Re: Fish and Wildlife Coordination Act Report for the Upper Trinity River Modified Central City Project Fort Worth, Texas

This letter constitutes the U.S. Fish and Wildlife Service's (Service) final report on the Fort Worth District, U.S. Army Corps of Engineers' (Corps) Modified Central City Project in accordance with Section 2(b) of the Fish and Wildlife Coordination Act (FWCA) (48 Stat. 401, as amended; 16 U.S.C. 661 *et seq.*). The purpose of this report is to identify and evaluate anticipated impacts of merging and implementing the proposed changes to the authorized Central City and Riverside Oxbow Projects on fish and wildlife resources within the Trinity River floodplain in Tarrant County, Texas and to recommend conservation and mitigation measures for fish and wildlife resources. Our report has been coordinated with the Texas Parks and Wildlife Department (TPWD) as noted in the enclosed February 26, 2008 letter from Wildlife Habitat Assessment Program Biologist Karen Hardin.

Central City
Figure 1 - Recommended Valley Storage Plan
 (DRAFT - 8/24/07)

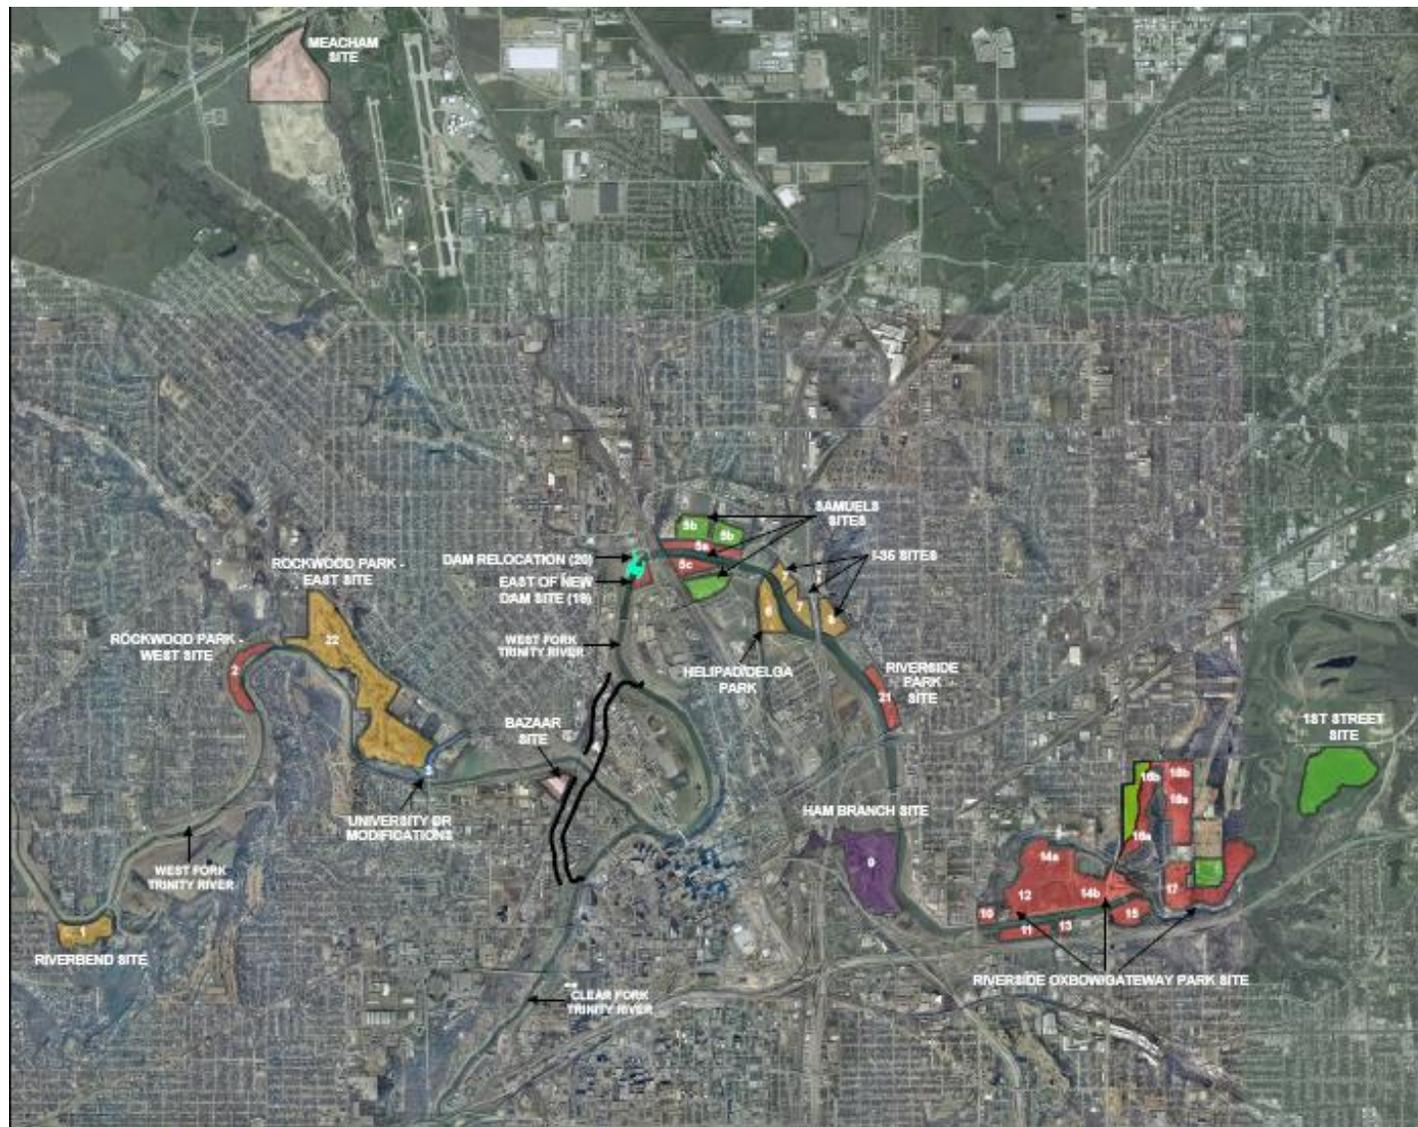
The Service's *Habitat Evaluation Procedures* (HEP) (USFWS 1980), described in the Service's June 18, 2004 planning aid report (Hale and Giggelman 2004), was used to evaluate the existing terrestrial habitats in the proposed valley storage sites in the same manner as it was in the Central City and Riverside Oxbow projects (Figure 1). The Service conducted additional assessments at the old Waste Water Treatment Plant (WWTP) in Gateway Park (Valley Storage Site 17) because it was determined that the Riverside Oxbow assessment no longer correctly represented the habitat within the drying beds.

Central City
Figure 2. Modified Central City Project Alternative

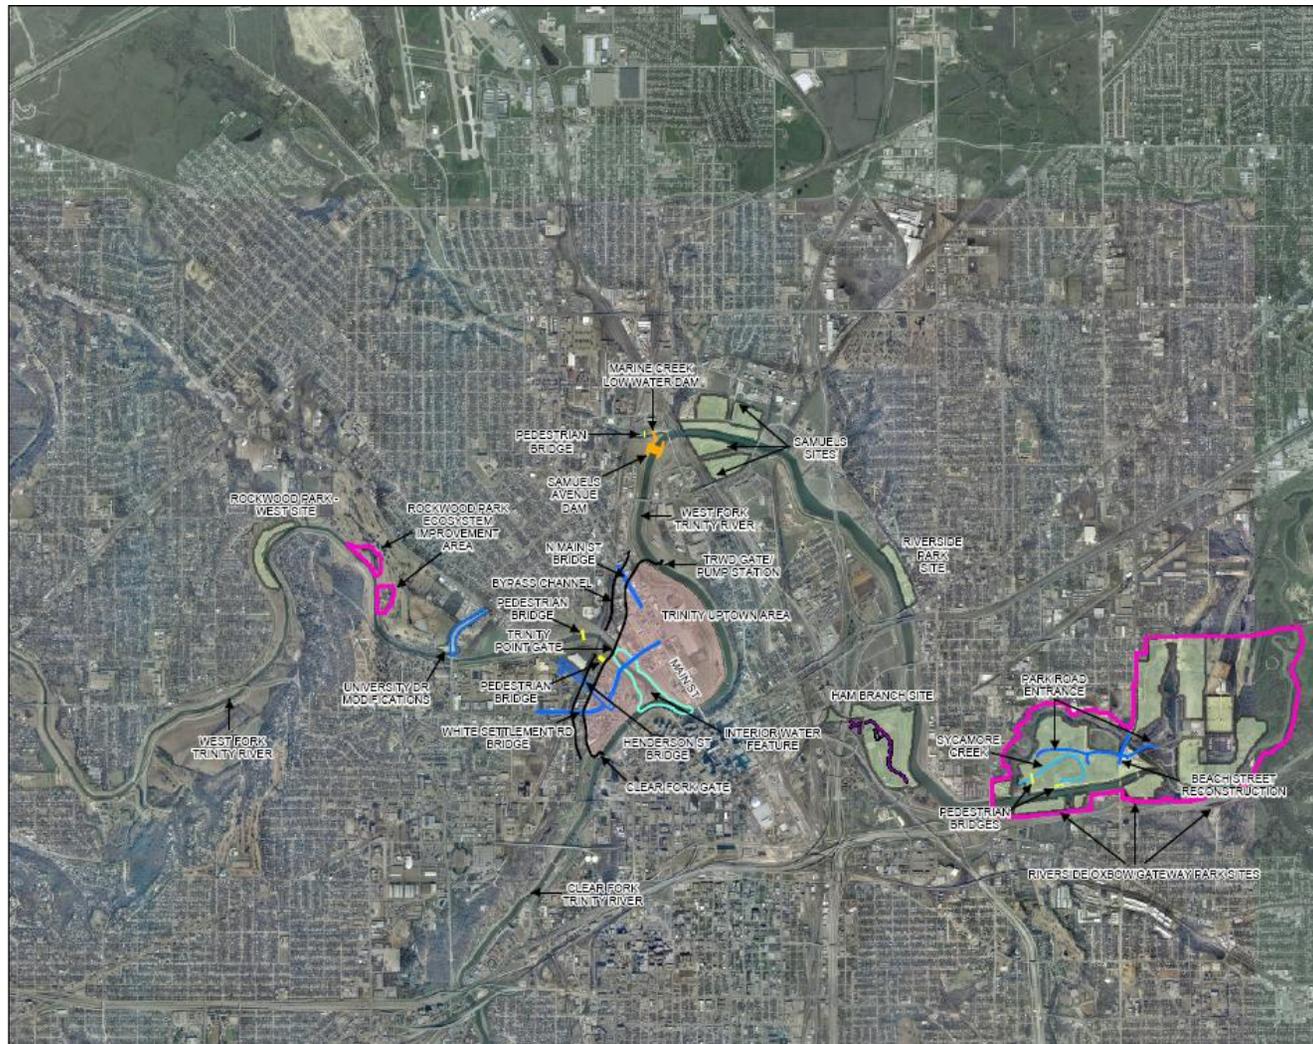
The modified plan includes 21 preferred and five contingency valley storage sites proposed along the Trinity River to provide approximately 5,250 acre-feet of flood water storage. The sites, which are located within the floodplain and on City of Fort Worth and TWRD owned property, are located predominantly in habitats of poor quality. Most of these sites would be excavated to acquire more acre-feet of storage. However, after excavation these sites are proposed to be restored into equal or higher quality habitat than their existing condition. Most of the habitat restoration and mitigation would be located in these sites.

The modified plan would minimize acquisition of private lands by relocating the valley storage sites to public lands and concentrating wildlife habitat mitigation in the Riverside Oxbow project area. The modified project proposes to exclude Riverbend Park from the project for habitat mitigation, but includes it as a contingency valley storage site if additional storage is necessary. The modified plan would require compensation for loss of about 18.3 acres of riparian woodlands, 59 acres of upland woodlands, 2.3 acres of aquatic habitat, and less than an acre of emergent wetlands. However, it includes establishing 58 acres of wetlands, restoration of 10.9 acres of stream and oxbow habitat, developing of 137.6 acres of riparian woodland, enhancement of 263.6 acres of existing riparian woodland, development of 87 acres of native grassland/savannah, and enhancement of 53.3 acres of native grasslands. The Modified Central City Alternative would increase riparian woodland habitat by 109 Average Annual Habitat Units (AAHUs) and emergent wetlands by 47.78 AAHUs. The negative impacts to upland woodland habitat would be partially compensated by out-of-kind mitigation using the additional riparian woodlands developed beyond those required to fully compensate for the existing riparian woodlands that would be impacted. The total acreage and AAHUs for existing grassland habitat would decrease because mitigation for the other higher quality habitats is proposed in poor quality grasslands on public lands.

The Service supports the proposed Modified Central City Alternative aquatics mitigation plan that proposes developing additional stream mitigation features in Sycamore Creek and Ham Branch as mitigation for the impacts associated with inundation of Marine Creek. Mitigation would include construction of a series of riffle pool sequences with a stable streambed supported by stable banks and a riparian corridor in both streams. We recommend using natural soft engineering for bank stabilization. The streams should have a sufficient longitudinal profile (slope) to maintain adequate flow regimes. Substrate composition should be similar to the habitat in Marine Creek.

We also support restoring the old remnant of Sycamore Creek between Riverside Oxbow and the river. Providing a reliable water source and restoring the aquatic function of this segment of Sycamore Creek would benefit aquatic species and contribute to the mitigation requirement for the impacts associated with inundating Marine Creek. Habitat restoration benefits would not be fully realized for several years, but the newly planted aquatic vegetation proposed in the mitigation plan would probably be well established within one year.
